AEP:NRC:3054-08
10 CFR 2.202

Donald C. Cook Nuclear Plant Unit 1 and Unit 2
REVISED RESPONSE TO REQUEST FOR ADDITIONAL INFORMATION REGARDING RELAXATION OF REACTOR PRESSURE VESSEL HEAD PENETRATION INSPECTION REQUIREMENTS IN NUCLEAR REGULATORY COMMISSION ORDER

REVISED RESPONSE TO REQUEST FOR ADDITIONAL INFORMATION

ATTACHMENT 3 TO AEP:NRC:3054-08
CRACK GROWTH CURVES

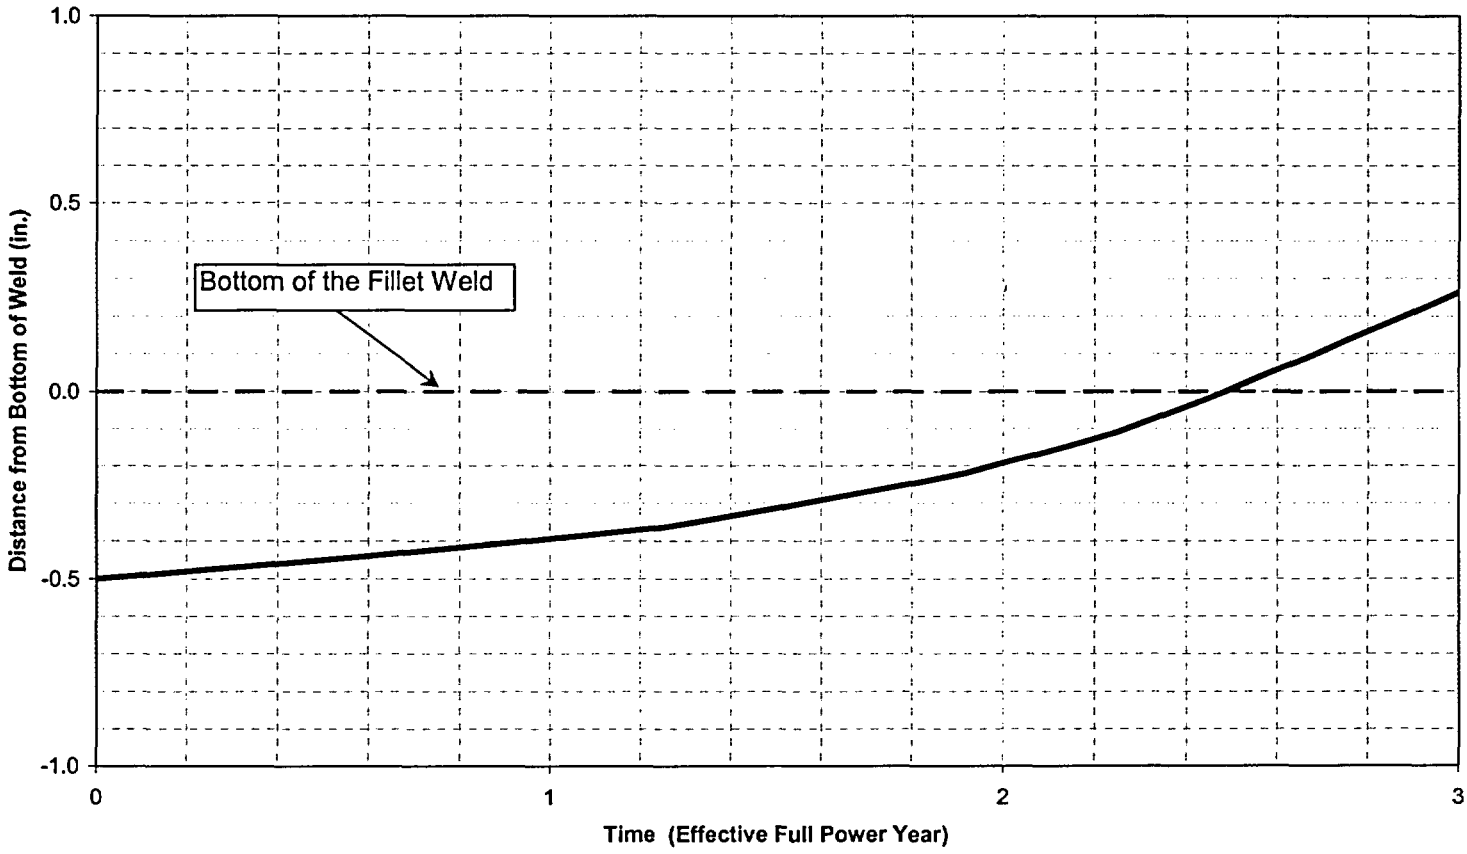
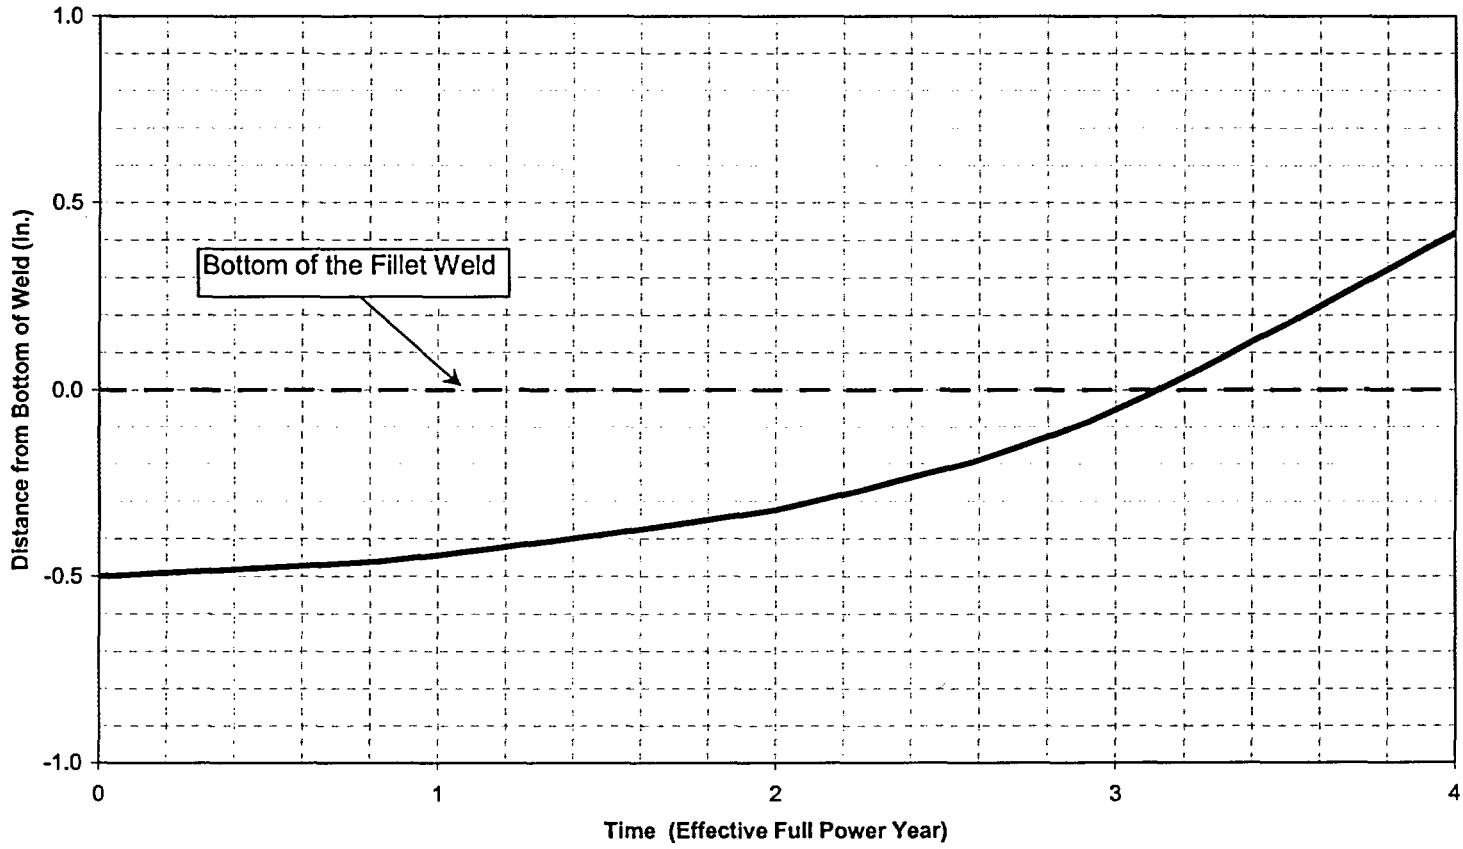
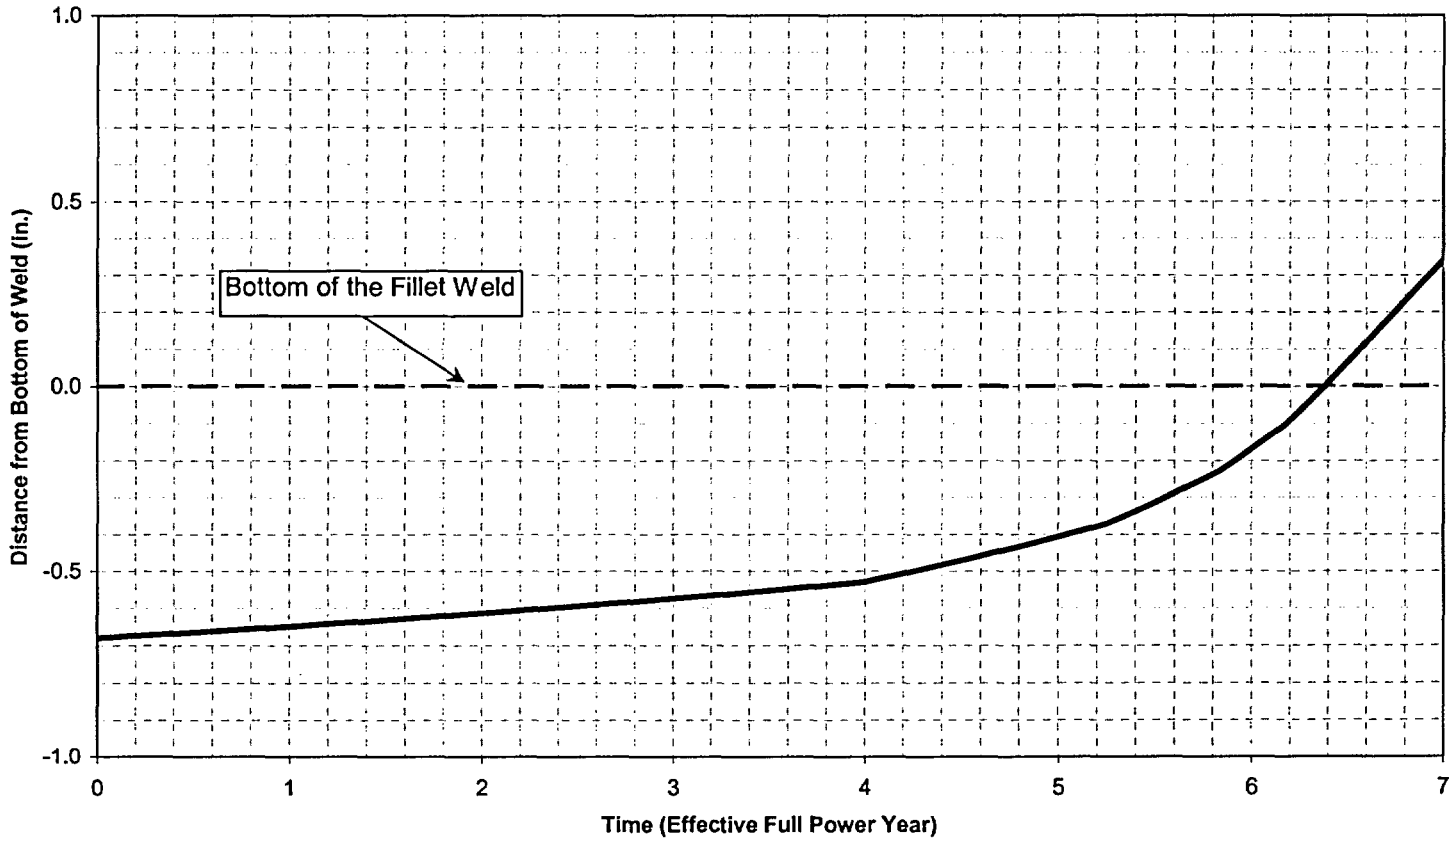
Provide additional technical justification (i.e., operating stress levels, crack growth analysis, etc.) that supports the licensee's statement that the small area that cannot be scanned is insignificant to the phenomena of concern.

The licensee references a crack growth analysis report. What is the report number, and has this been submitted previously to the NRC? If a crack growth analysis is used that is different than that previously submitted, explain the differences.

Why is the postulated flaw given a depth of 80 percent of the wall thickness instead of 100 percent of the wall thickness? The former does not appear to be conservative.

The calculations were performed for the three outer penetration rows (45.8°, 47.0°, and 50.5° in Attachment 2). The results of these calculations are illustrated by the four crack growth curves provided in Attachment 3 to this letter. The first three curves show that it would take more than 2.3 effective full power years for the postulated flaw 0.5 inches below the J-groove weld to propagate to the bottom of the weld. This time period is more than the minimum under-head inspection interval for Unit 2 (one operating cycle) required by NRC Order EA-03-009. For rows other than the three outer rows, the inspectable length exceeds 1 inch, based on best estimates by personnel reviewing ultrasonic inspection results. The 1 inch inspectable length provides a conservative factor of 2 with respect to the crack growth distance assumed in the calculations. The effect of additional inspectable length on crack growth times is illustrated by a comparison of the first and fourth curves in Attachment 3. These curves show that an increase in inspectable length of 0.18 inches results in an increase of approximately 4 effective full power years in the time it would take a flaw in the uninspectable area to reach the J-groove weld for the third outermost row.

In the crack growth calculation described in Reference 6, the flaw was postulated to be 80 percent through the nozzle wall, since this is the maximum value given in Table A-3320-2 in Appendix A to Section XI of the American Society of Mechanical Engineers Boiler and Pressure Vessel Code. However, a flaw depth of 100 percent was assumed in the above described crack growth calculations.

The one exception occurs on penetration 73. On penetration 73, the minimum distance from the J-groove weld to the threaded area has been determined to be 0.36 inches based on best estimates by personnel reviewing the ultrasonic inspection results. The tolerance on this value is estimated to be plus or minus 10 percent. Since this distance is less than the 0.5 inch value assumed for the location of a postulated flaw in the crack growth calculations described in the response to NRC Question 2, I&M has performed surface examination of the areas below the 0.36 inch distance on penetration 73. The surface examination consisted of eddy current testing of the inside diameter surface down to the top of the chamfer and penetrant testing the threaded surface of the outside diameter down to the bottom of the threads. These surface examinations extended the inspected area beyond 0.5 inches below the J-groove weld. Penetration 73 is in the next to outermost row. The Attachment 3 curve for the next to outermost row shows that it would take a flaw 0.5 inches below the J-groove weld on penetration 73 more than 2.5 effective full power years to propagate to the weld.
